electrical engineering exam

Exam Submission

BEng Electrical & Electronic Engineering
ACDA5001 – Electrical Engineering

3.b

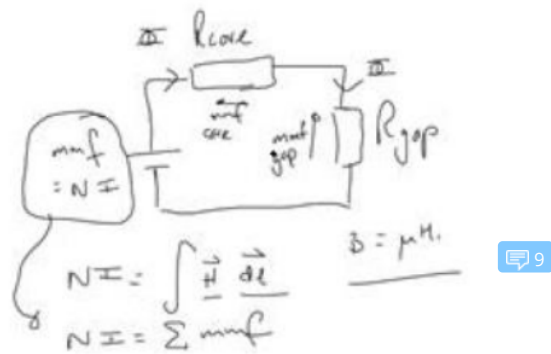
Comment 7

Q3a) correct (ignoring the m in place of M) - 10 Marks

Q3b) correct (ignoring the m in place of M) - 10 Marks

Comment 8

Should be MVA not mVA. there is a factor of a billion between these two.
